Inspector's Report

CORRIB GAS PIPELINE

16. GA.0004

Re-routing of the onshore upstream gas pipeline facility relating to the Corrib Gas Field Project at Glengad, Ros Dumhach, Aghoos, Bellagelly South, Co. Mayo

LUP zones versus BPD and Easements

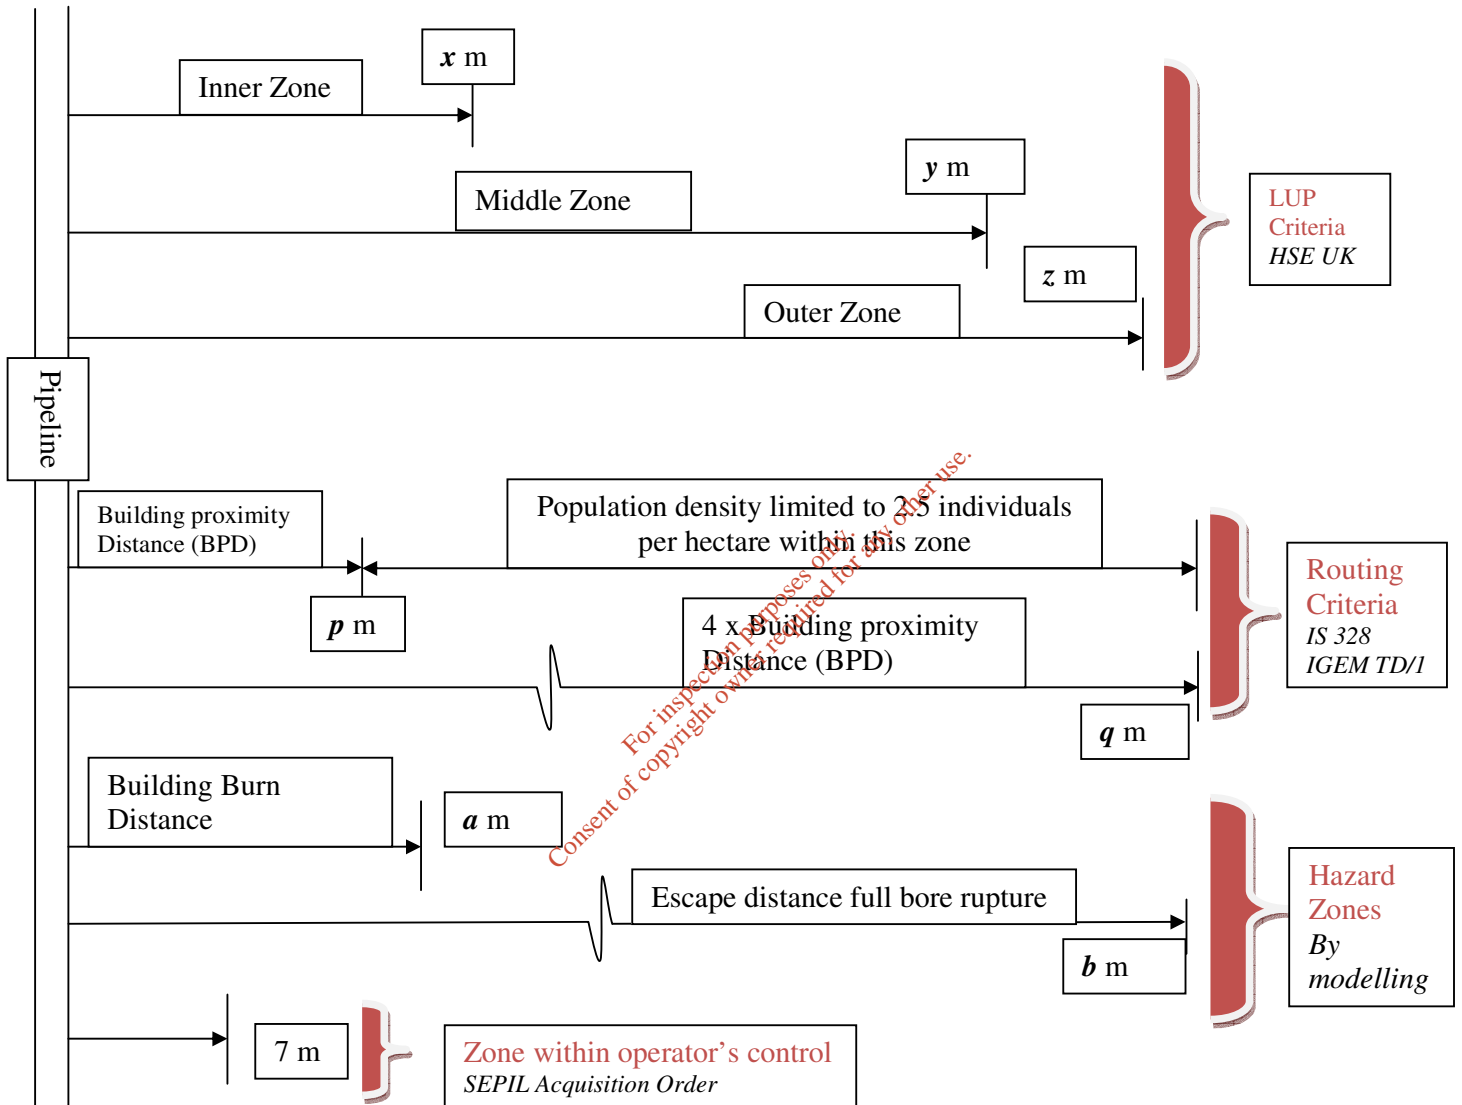
The diagram illustrates a number of important and different systems of evaluating the consequence zone along gas pipelines. Each of the different systems provide guidance and a recognised method to assist decision making regarding the safety, risk, restrictions, consequences of failure along gas pipelines.

FIGURE 2 PRESSURE VS TIME PROFILE FOR CORRIB GAS FIELD (PLOTTED FROM TABLE 2)

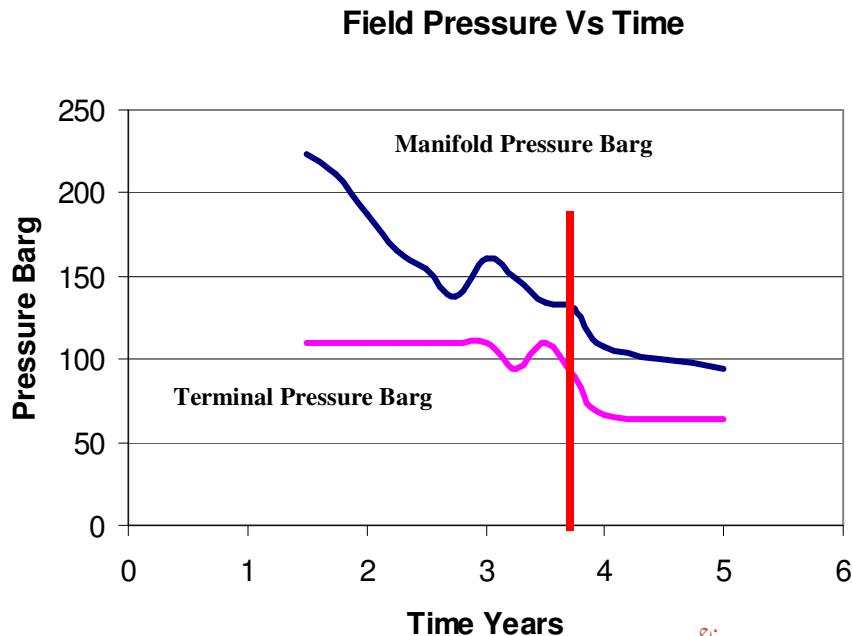
Figure 2 shows the early gas pressures from the 1st year to the 5th year. Up to year 3, the high pressure is controlled by the subsea choke giving a constant 110barg at the terminal. Thereafter the pressure at LVI and the terminal is control by the falling well pressure and the pressure drop in the pipe.

FIGURE 4 BASIC FLOW DIAGRAM AND VALVE ARRANGEMENT OF GLENGAD LVI

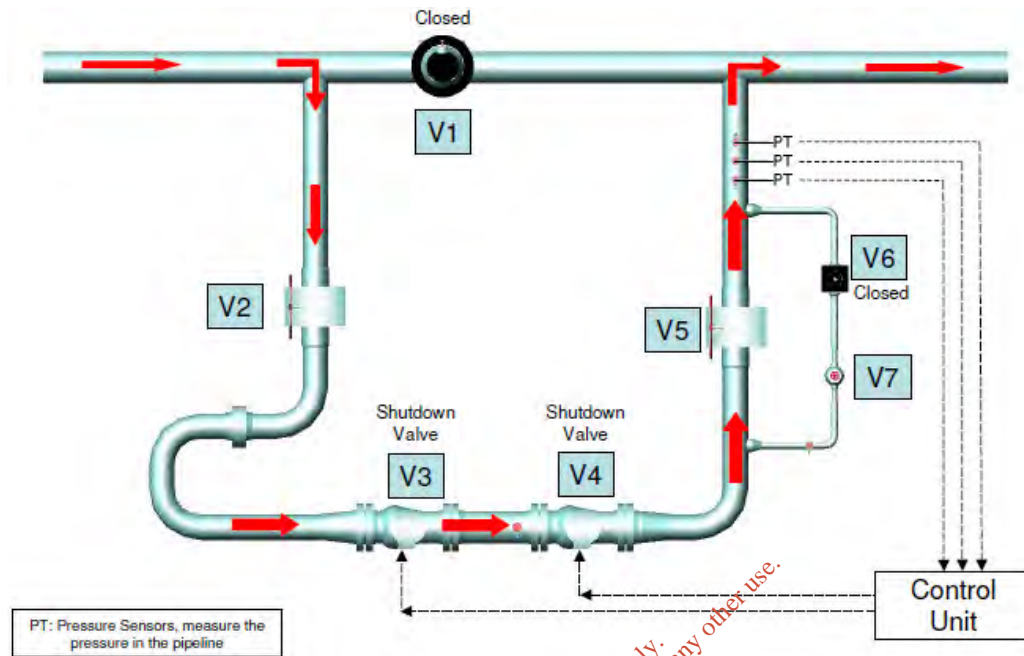
The gas industry is fully aware of valve sealing problems, which is why on critical valve installations a double block and bled arrangement is specified. This arrangement is present on the HIPPS loop Landfall Shutdown Spool Isolation Valves (LSSIV) (shown in Fig 4 as valves V2 & V5) and on the Landfall Restart Spool Isolation Valve (LRSIV), (shown in Fig 4 as valve V6) but is not specified on the Landfall Main isolation Valve (shown in Fig 4 as valve V1). If fitted to V1 there would be a chance that a constant bleed of gas would occur at LVI, which could change the zone rating. Therefore it is possible for High Pressure (HP) gas to bleed past a scored sealing face on valve V1.

FIGURE 8 RELATIONSHIP BETWEEN RISK AND ZONE BOUNDARIES

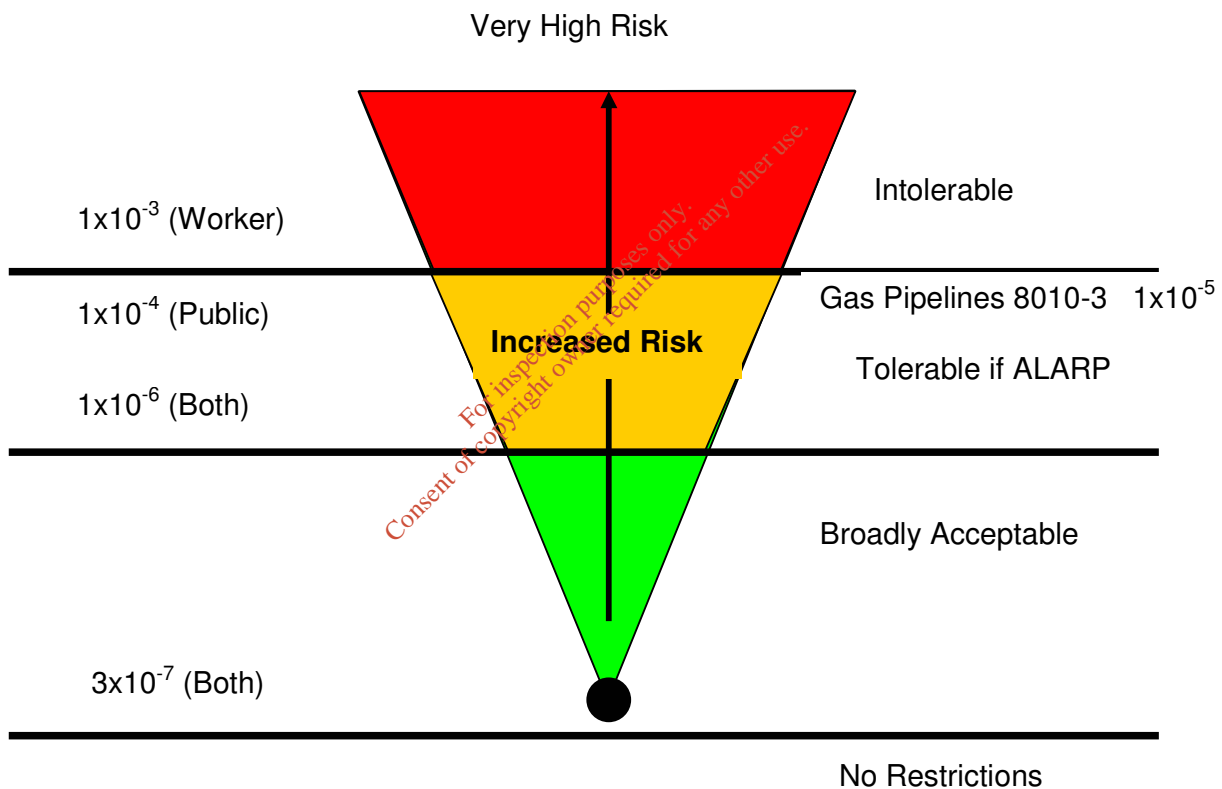
The Individual and Societal Risk based criteria use different values for the Dangerous Dose. The UK HSE Land Use Planning (LUP) Zones for individual are based upon 1000 TDU, shown in Figure 8. Both IGEM/TD/2 and PD8010-3 adopt the HSE method for their Individual Risk Analysis.

FIGURE 9 PD8010-3 SOCIETAL RISK F/N DIAGRAMME & RISK CRITERION LINE

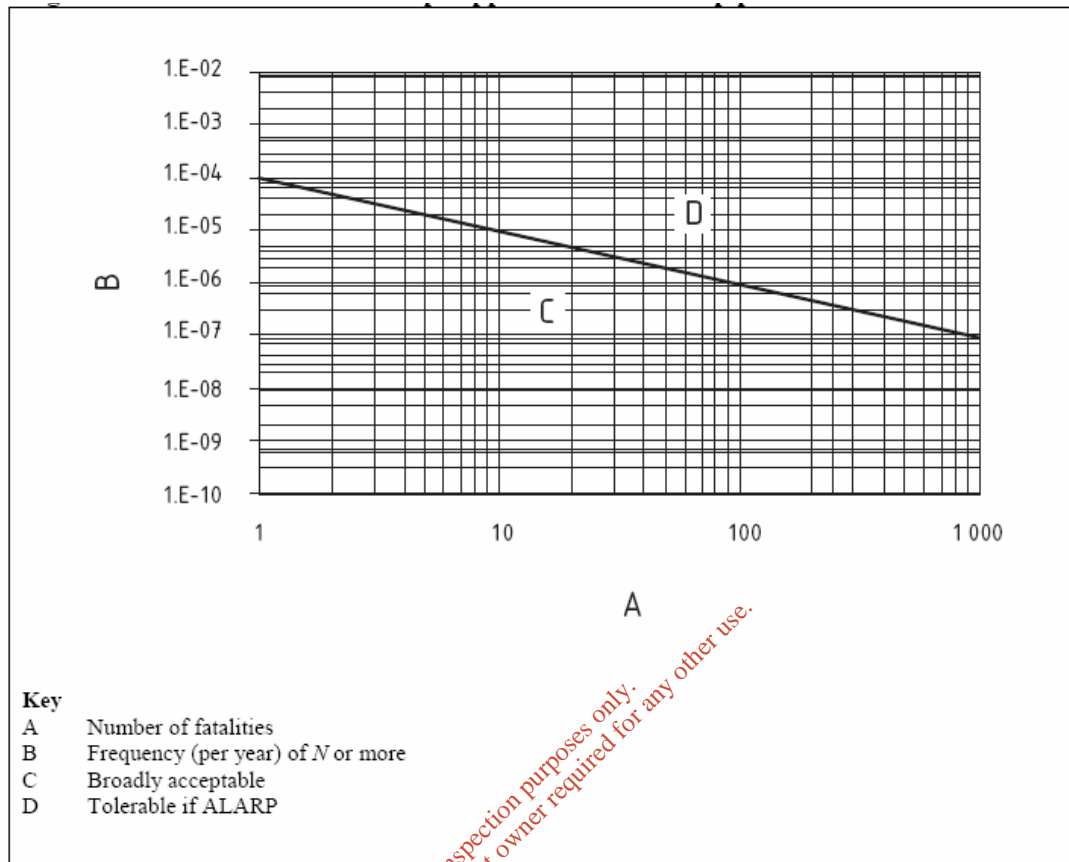
Figure 9 shows a graph of Frequency of Failure/ Year (B) against the No of Casualties (A). This is known as a F/N diagramme.

FIGURE 17 INDIVIDUAL RISK TRANSECTS 144BARG FOR RESIDENTS AT GLENGAD LVI

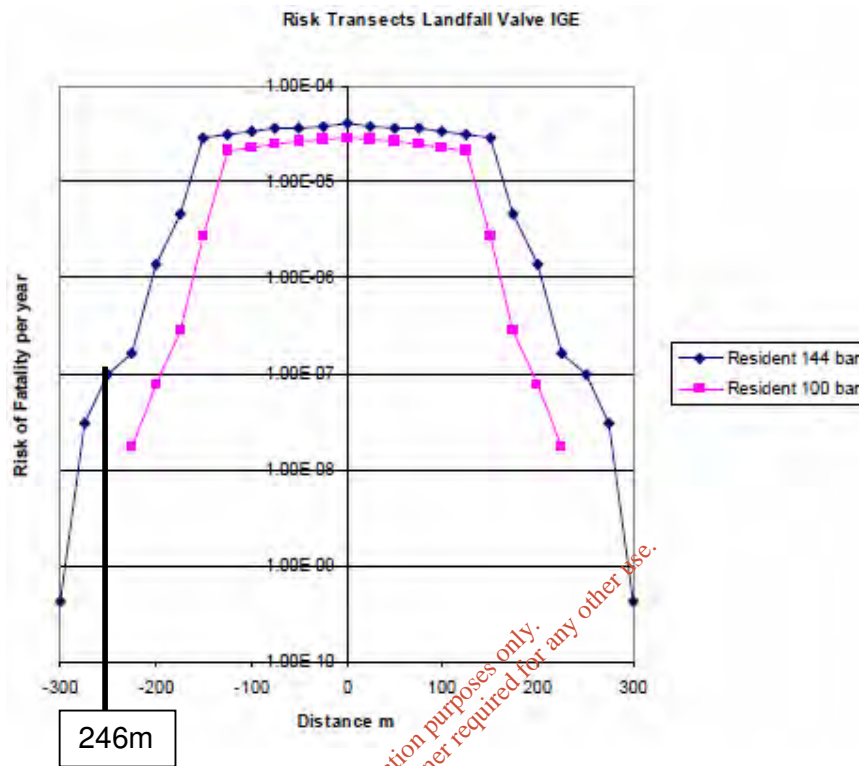
Figure 17 (EIS Appendix Q Section 4 Figure 5), shows the risk to the residents at Glengad when the LVI is at 144 barg. The risk at the nearest dwelling drops to 1E-07, which is broadly acceptable.

FIGURE 18 INDIVIDUAL RISK TRANSECTS 144BARG FOR RESIDENTS ALONG THE PIPELINE AT ROSS PORT

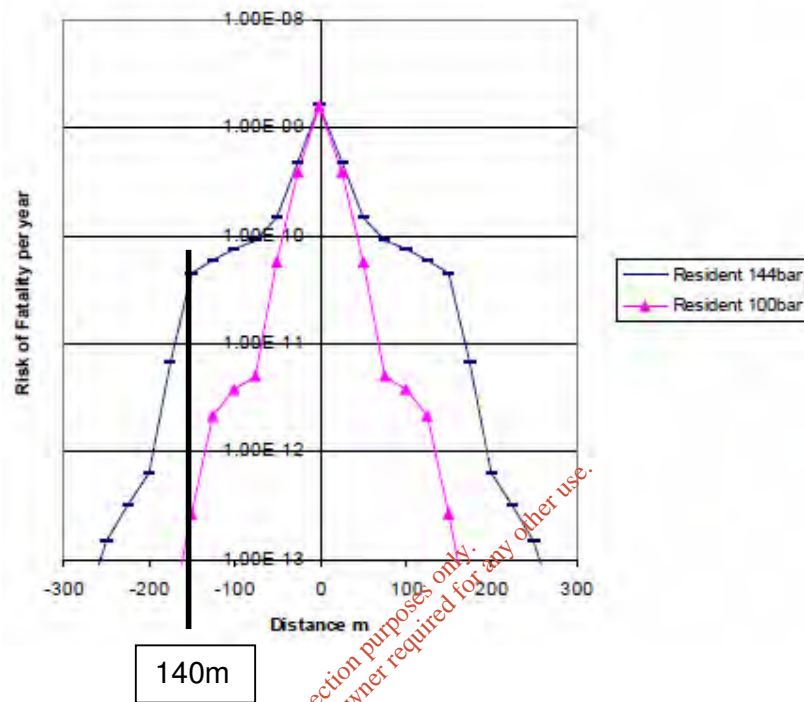
Figure 18 (EIS Appendix Q Section 4 Figure 4), shows Individual risk transects when the pipeline is at 144barg for residences along the pipeline at Ross Port

FIGURE 24 CASE 3 INDIVIDUAL RISK TRANSECTS 345 LVI 144 BARG PIPELINE

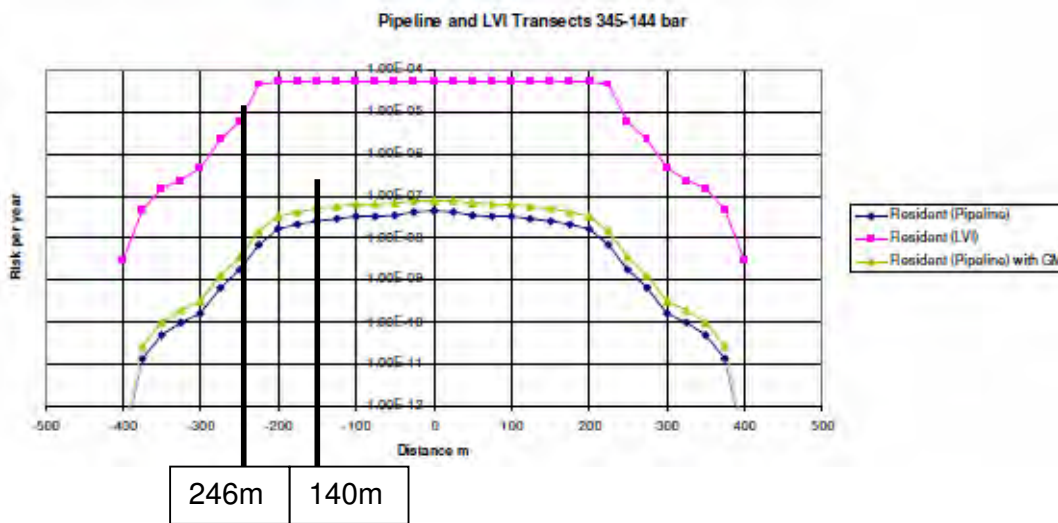
Figure 24 shows the 345 barg risk to the Glengad residents (Red 3E-06 ALARP) and the risk to the Ross Port residents (blue 5E-8) and (green with ground movement 7E-08)
